## **Rymill Park Apartments Pty Ltd and Rymill Park Apartments Unit Trust**

Demolition of existing office building and construction of 16 level mixed use building with basement and associated car parking

### **2-6 Hutt Street, Adelaide**

DA Number 020/A053/19

**Figure 5: Stored vehicle in aisle obstructing access for turning vehicles**

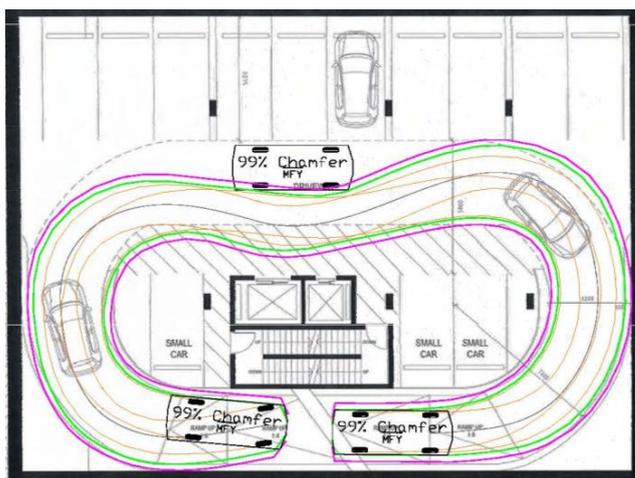
- The Infraplan report suggests that drivers will be able to pass within the car park aisles. However, the turning radii of vehicles accessing the ramp mean that there will be inadequate area for drivers to pass on the aisles, as illustrated in Figure 5.

**Figure 8: Swept path of MRV accessing the loading zone**

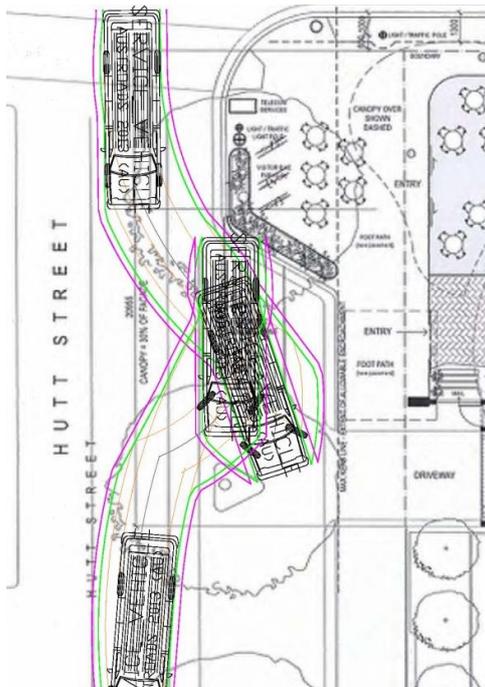
- The proposal will rely on loading in Hutt Street. If such an arrangement was considered acceptable by Council (given that it would require a parking zone to be implemented and loss of a number of on-street spaces), it would only accommodate a small rigid vehicle. It is anticipated that the café would require deliveries by a medium rigid vehicle (MRV) which would obstruct the access, as illustrated in Figure 8.

Figure 1 - Edge of shadow at 12:51 on 21 June 2019

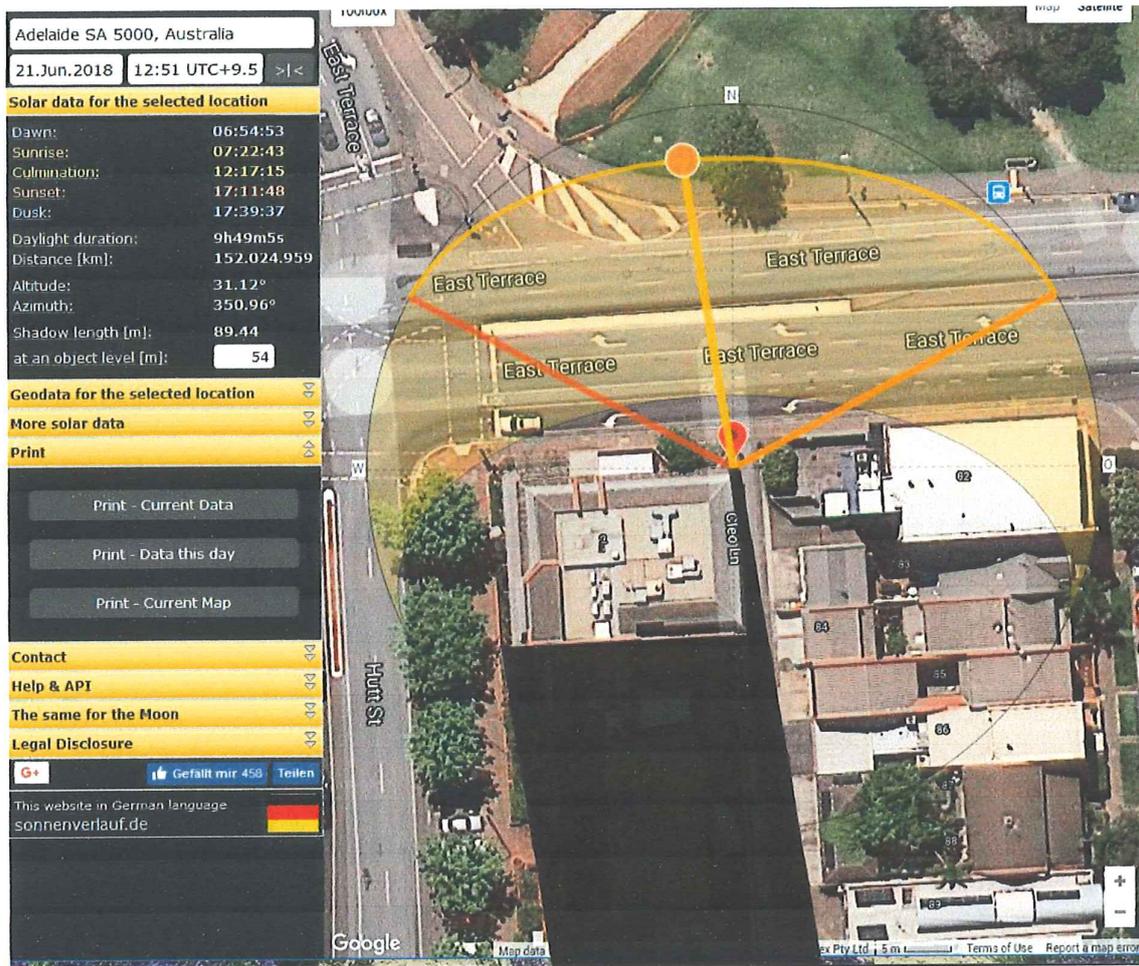
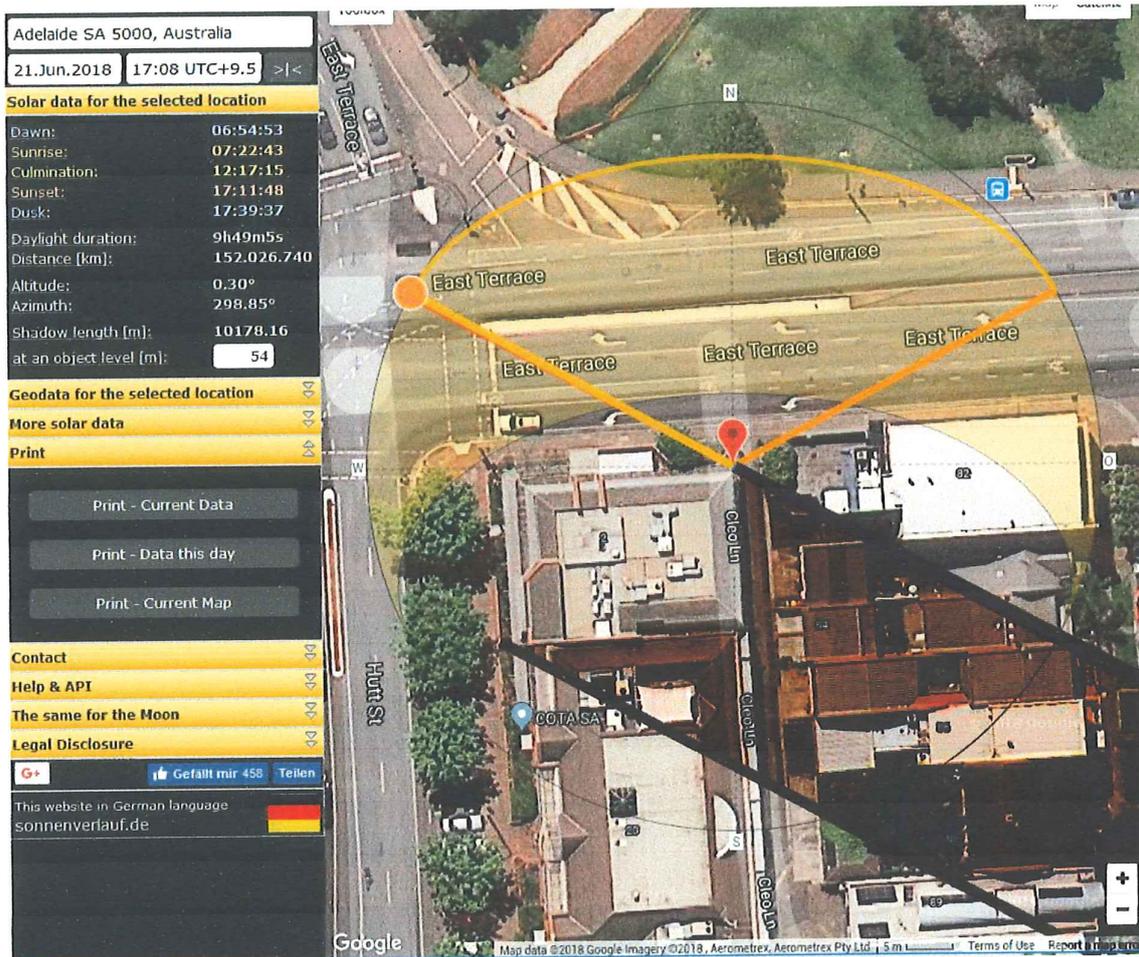
The DP now provides information on solar shading. An edifice 53.9m high and 27m wide will seriously reduce the amount of sunlight available at 85 East Terrace at any time of year. Figures 1 and 2 below show that the proposed development will, on the 21<sup>st</sup> of June 2018, cast a shadow over 85 East Terrace commencing at 12:51pm and remaining until dusk. The statement in Section 7.7.1 Overshadowing that a building of 54m would have negligible extra impact over a building of 22m is manifest nonsense. The shadow cast will extend more than twice as far down East Terrace. It will affect properties much further down East Terrace.

Figure 1 - Edge of shadow at 12:51 on 21 June 2019

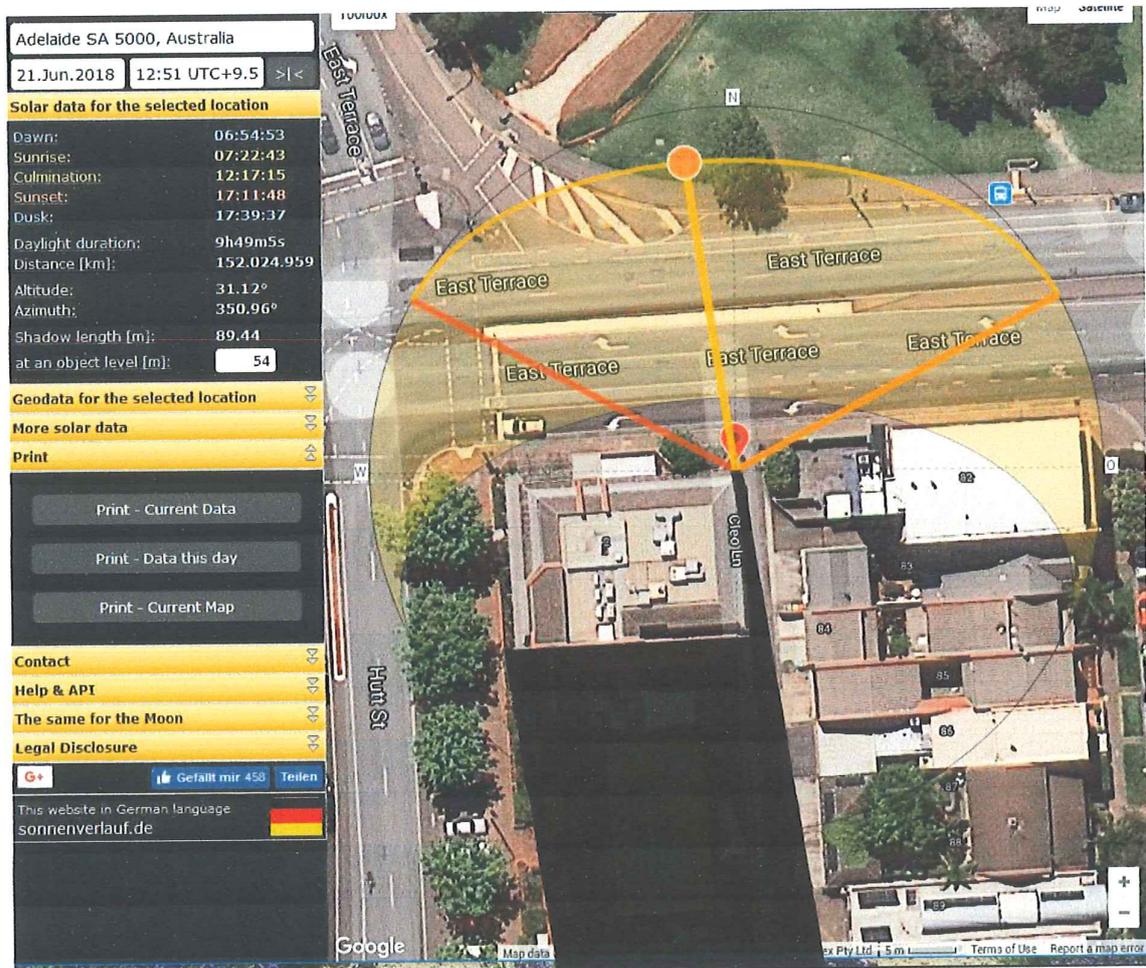
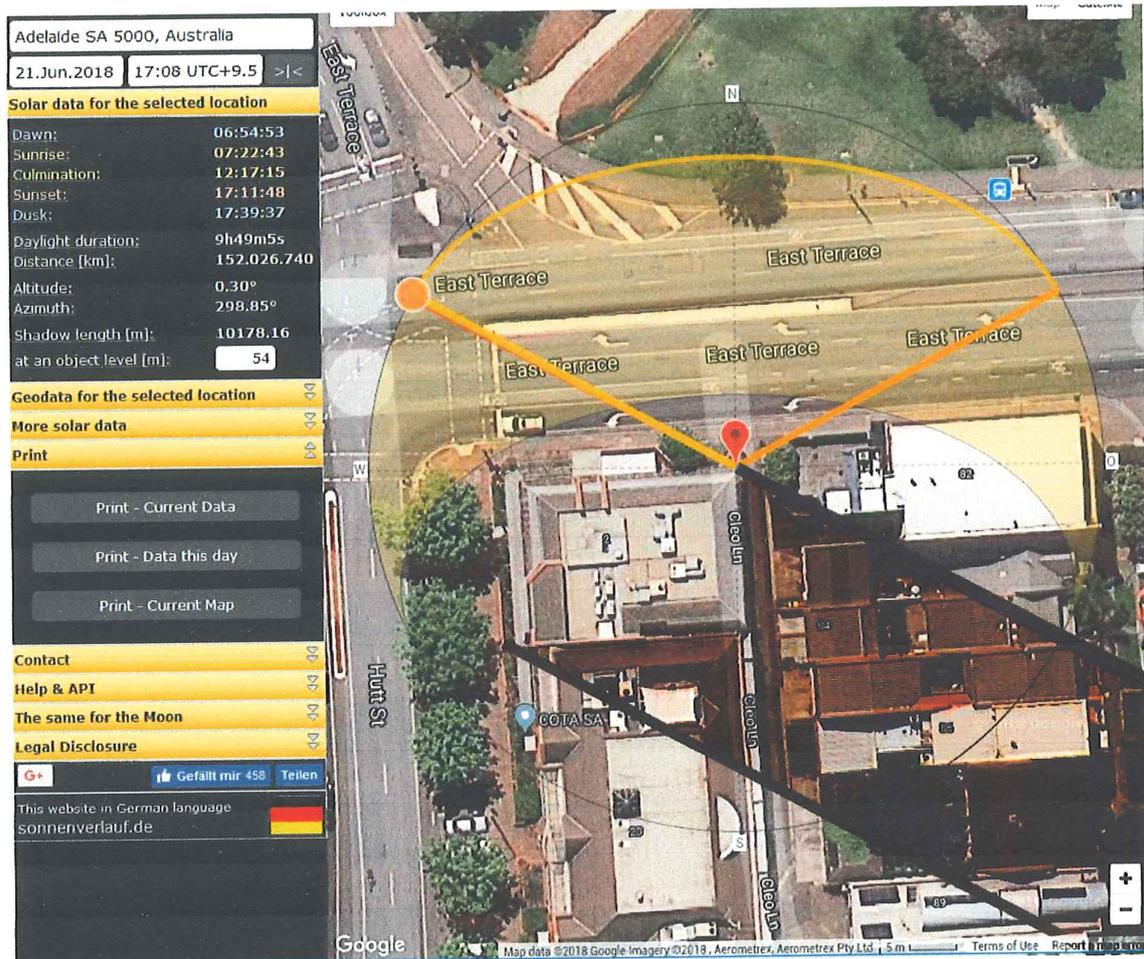
The effect of solar shading has been calculated independently. An edifice 53.9m high and 27m wide will seriously reduce the amount of sunlight available at 85 East Terrace at any time of year. Figures 1 and 2 below show that the proposed development will, on the 21st of June 2019, cast a shadow over 85 East Terrace commencing at 12:51pm and remaining until dusk.

The statement in Section 7.9.7 Overshadowing that a building of 54m would have negligible extra impact over a building of 22m is manifest nonsense. The shadow cast will extend more than twice as far down East Terrace. It will affect properties much further down East Terrace.
